## SERVICE BULLETIN

Subject: Transmittal of Revision 1 to Service Bulletin V2500-ENG-72-0347.

ENGINE - HP COMPRESSOR DISKS (STAGES 9-12) - INTRODUCTION OF REVISED HP  
COMPRESSOR STAGE 9-12 DISK ASSEMBLY WITH INCREASED ABRASIVE LINING BOND  
COAT THICKNESS

**V2500-ENG-72-0347**

Figure 1

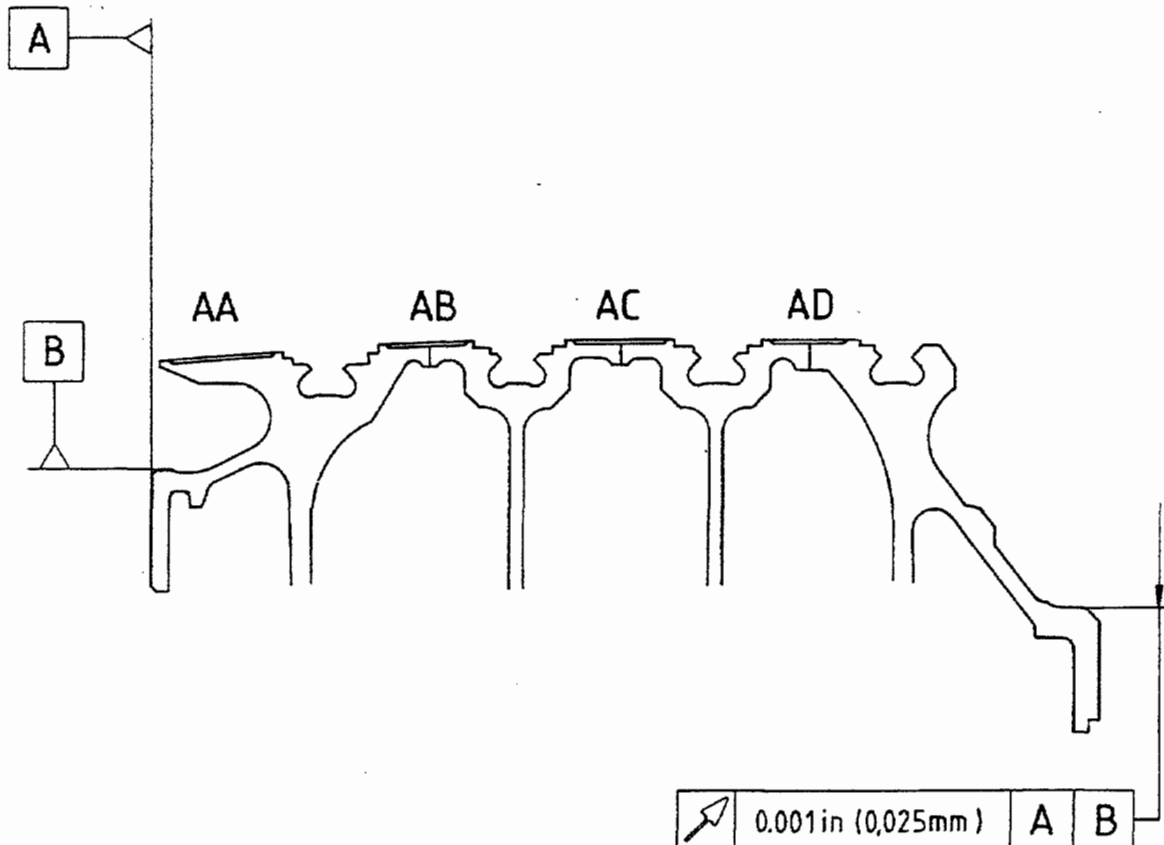
See Figure 1  
Use CoMat 02-001 masking tape  
or Refer to operation 3. A.  
for approved vendor tools

See Figure 1.  
Refer to SPM  
TASK 70-12-02-120-501  
Use CoMat 05-001 abrasive  
with abrasive blast equipment

See Figure 1 and Figure 3  
Refer to SPM TASK 70-33-59-300-503  
Use CoMat 01-025 nitric acid HNO<sub>3</sub>  
with chemical cleaning equipment.  
Put the assembly into nitric acid  
solution and keep below surface  
until bubbles stop

See Figure 1  
Use CoMat 02-001 masking tape.  
Alternatively refer to operation 3. A.  
for approved vendor tools

See Figure 1, 5, 6 and 9  
Refer to SPM TASK 70-34-01-340-501  
SUBTASK 70-34-01-340-007  
Use CoMat 03-037 metal spray powder or  
CoMat 03-416 metal spray powder  
with metal spraying equipment.  
Apply a thickness of 0.008 to 0.010in.(0,203 to  
0,254mm.)

See Figure 1, 5, 6 and 9  
Refer to SPM  
TASK 70-34-01-340-501  
SUBTASK 70-34-01-340-013  
Use CoMat 03-043 metal spray powder  
with metal spraying equipment  
Apply a layer of sufficient  
thickness to get the correct  
dimensions after assembly is  
machined

See Figure 1, 5, 6, and 9  
Use NC lathe and dial test indicator  
Refer to operation 3. A. for approved vendor tools

See Figure 1, 5, 6, and 9  
Machine at 200 feet/min  
(60 metres per min.)

APPLY THE SPRAY COAT AS GIVEN IN THE  
PROCEDURE ON THE AREAS SPECIFIED **AV**.

THE SURFACES SPECIFIED **AU** TO HAVE A MACHINED SURFACE FINISH  
OF 125 TO 250 MICROINCHES (3,2 TO 6,4 MICROMETRES).

Figure 2

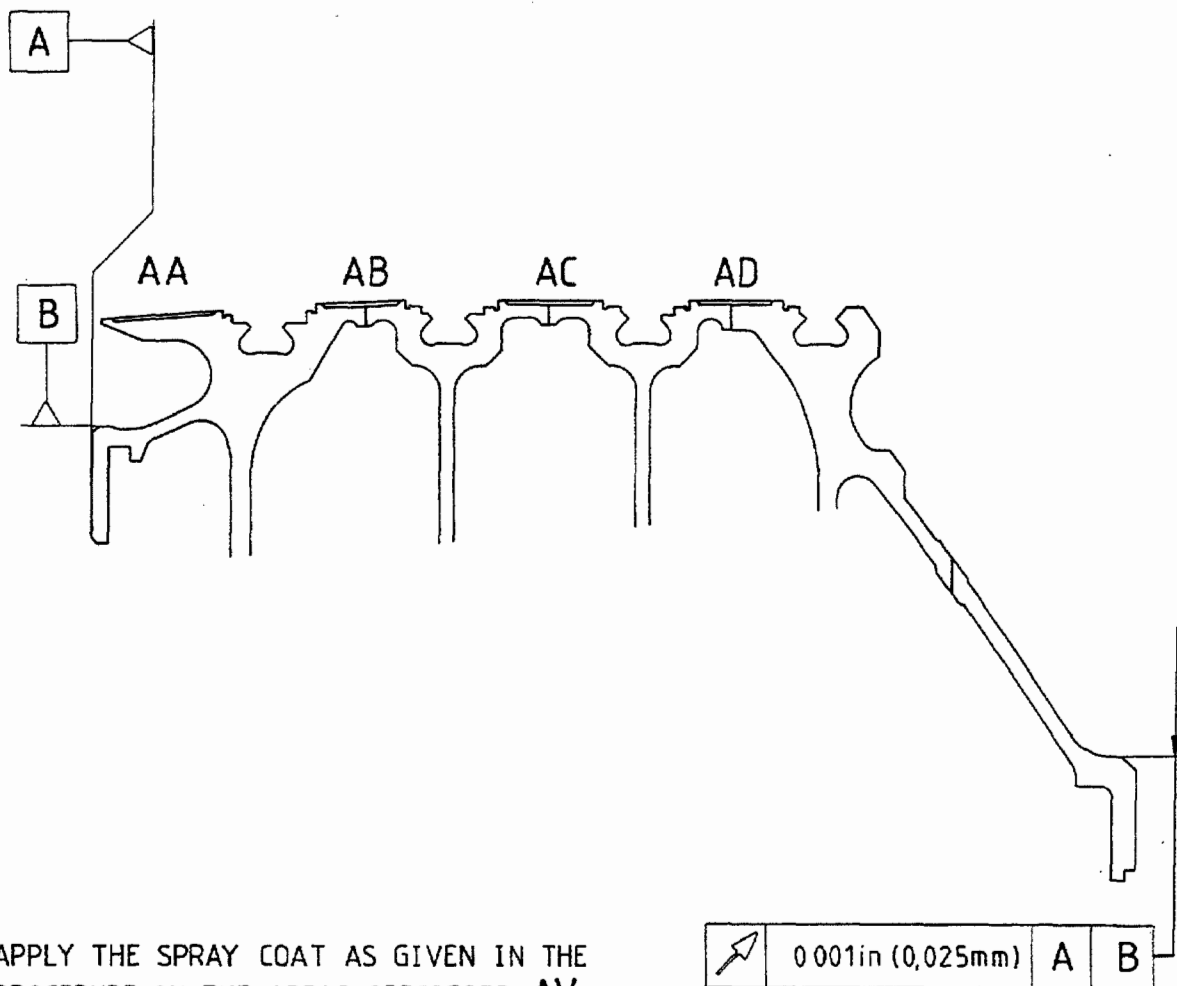
See Figure 2  
Use CoMat 02-001 masking tape  
or Refer to operation 3. A.  
for approved vendor tools

See Figure 2  
Refer to SPM TASK 70-12-02-120-501  
Use CoMat 05-001 abrasive with abrasive blast equipment

See Figure 2 and Figure 3.  
Refer to SPM TASK 70-33-59-300-503  
Use CoMat 01-025 nitric acid HNO<sub>3</sub> with chemical cleaning equipment.  
Put the assembly into nitric acid solution and keep below surface until bubbles stop

See Figure 2

See Figure 2, 7, 8 and 9

See Figure 2, 7, 8 and 9

APPLY THE SPRAY COAT AS GIVEN IN THE  
PROCEDURE ON THE AREAS SPECIFIED **AV**.

THE SURFACES SPECIFIED **AU** TO HAVE A MACHINED SURFACE FINISH  
OF 125 MICROINCHES (3,2 MICROMETRES).

Repair details and dimensions - (All Marks)  
Figure 3

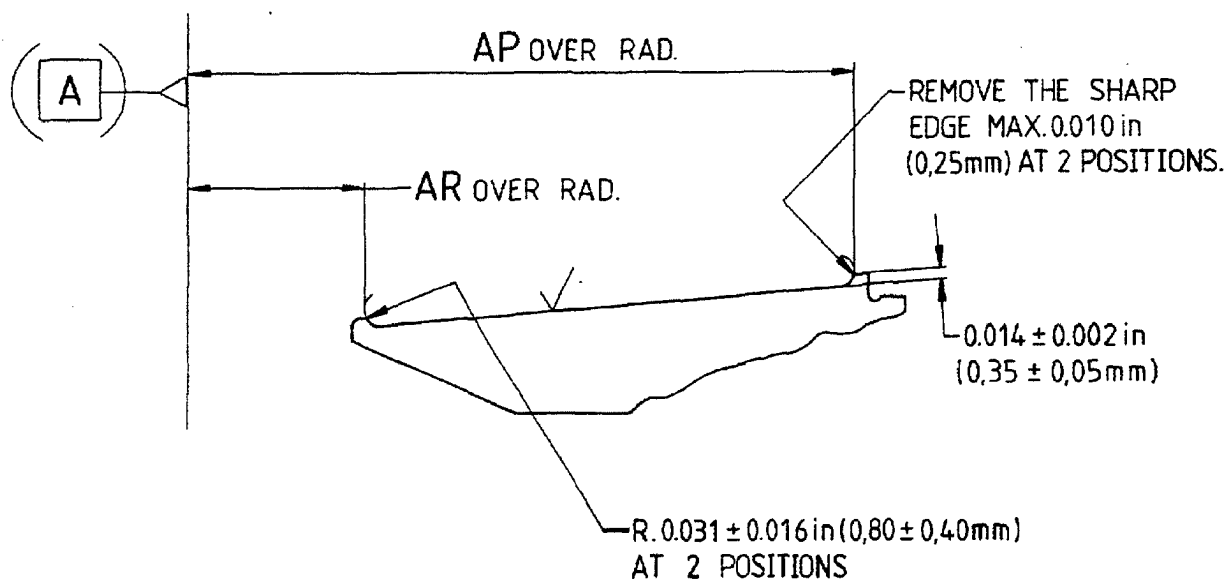
See Figure 3 and Figure 4  
Make sure all the lining material  
has been removed. If not do operation (b)  
and operation (c) again as necessary

See Figure 3 and Figure 4  
Use standard workshop tools.  
The depth of the groove must not be  
more than 0.016in. (0,40mm.)

See Figure 3 and Figure 4  
Make sure all the lining material has been removed. If not do operation (b) and operation (c) again as necessary

See Figure 3 and Figure 4  
Use standard workshop tools  
The depth of the groove must not be more than 0.016in. (0,40mm.)

Figure 5

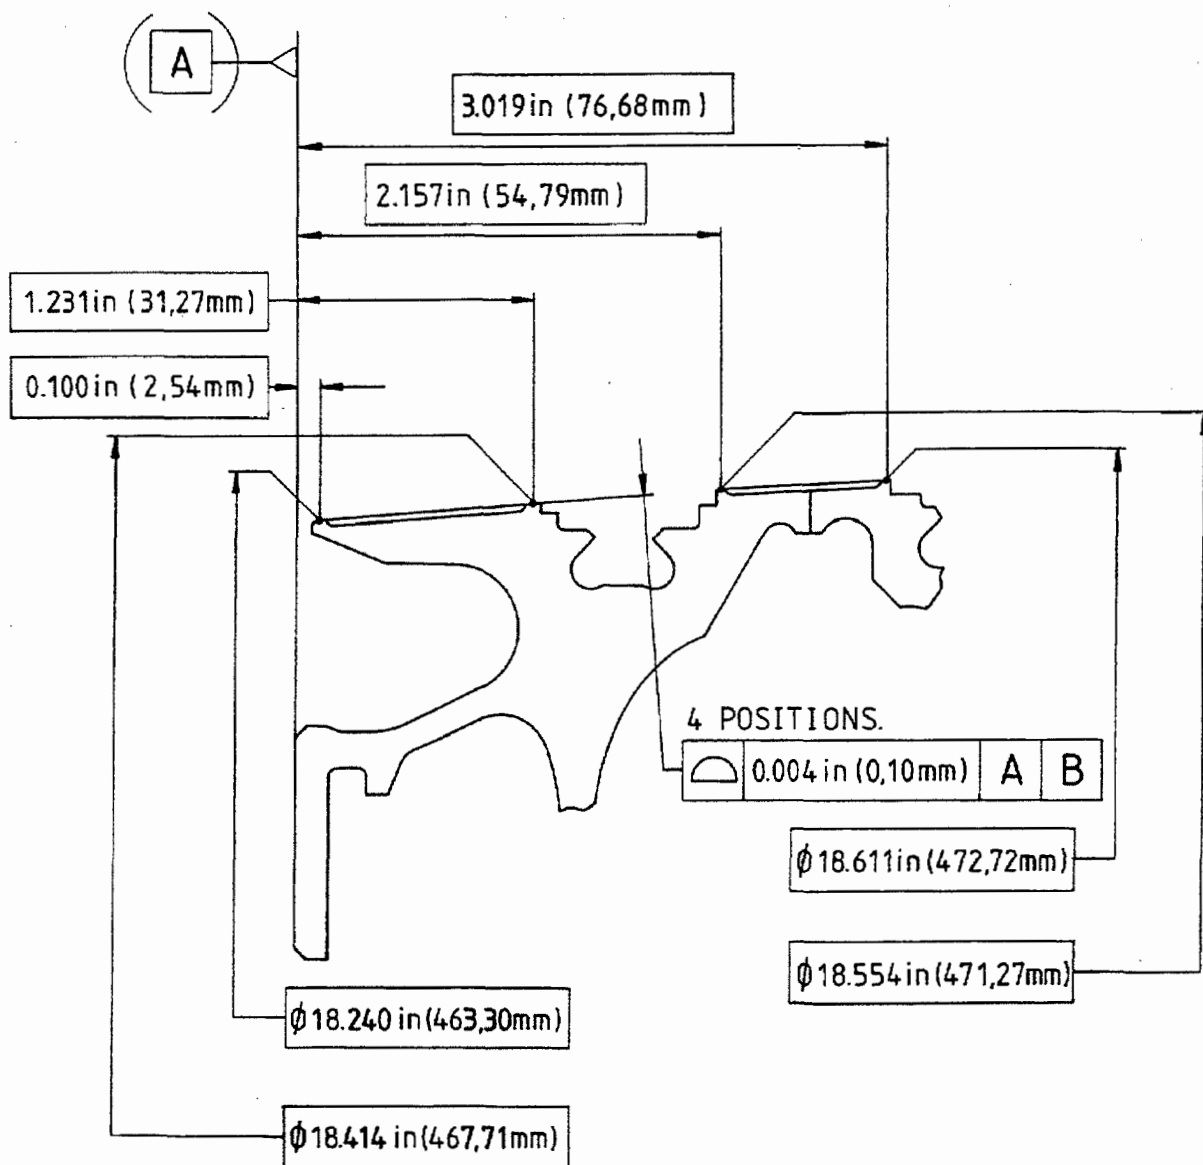
See Figure 1, 5, 6 and 9  
Refer to SPM TASK 70-34-01-340-501  
SUBTASK 70-34-01-340-002

See Figure 1, 5, 6 and 9  
Use standard workshop tools

Figure 8

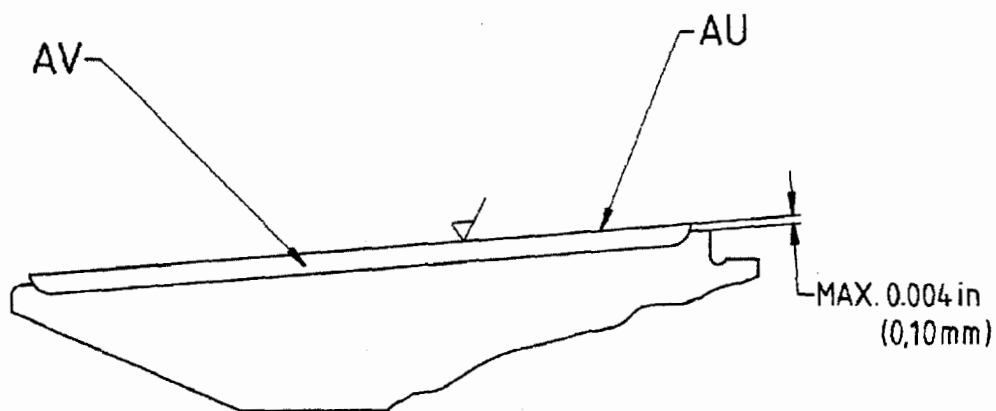
- (i) Set up the disk assembly to be machined
- See Figure 2, 7, 8 and 9  
Use NC lathe and dial test indicator  
Refer to operation 3 A, for approved vendor tools

- (ii) Machine the linings
- See Figure 2, 7, 8 and 9  
Machine at 200 feet/min  
(60 metres per min.)
- (l) Visually and Dimensionally Examine the Repair
- (i) Visually examine repaired area

- See Figure 2, 7, 8 and 9  
Refer to SPM TASK 70-34-01-340-501  
SUBTASK 70-34-01-340-002
- (ii) Dimensionally examine the repaired linings at each stage

- See Figure 2, 7, 8 and 9  
Use standard workshop tools
- (m) Clean the Assembly
- (i) Chemically clean
- Refer to TASK 72-41-12-100-000  
Use Chemical cleaning equipment

Repair details and dimensions - (All Marks)  
Figure 10

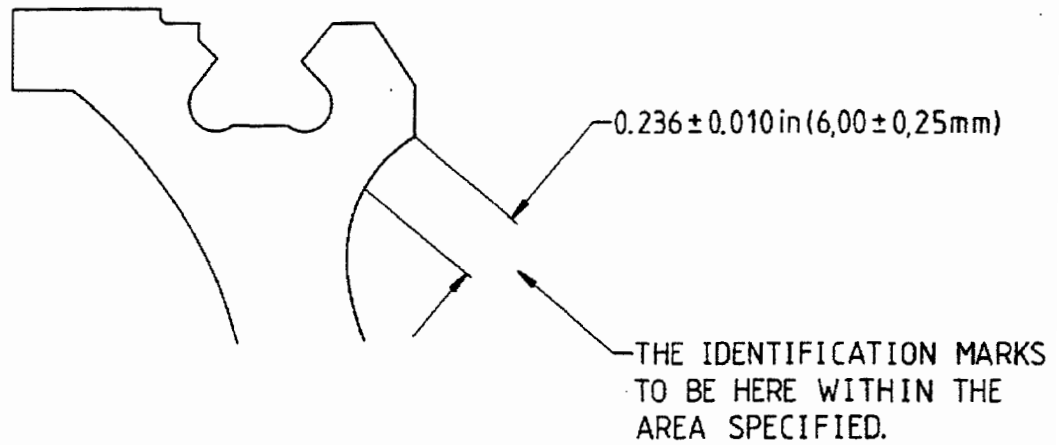
- (n) Cancel the existing part number and  
identify with the new part number.

See Figure 10  
Use vibro engraving equipment  
Refer to the Standard Practices  
Manual (SPM)  
TASK 70-09-00-400-501  
SUBTASK 70-09-00-400-001

- (n) Cancel the existing part number and identify with the new part number.
- See Figure 10  
Use vibro engraving equipment  
Refer to the Standard Practices Manual (SPM)  
TASK 70-09-00-400-501  
SUBTASK 70-09-00-400-001

6A4131

6A7545

6A6546	6A7546
6A4156	6A7547
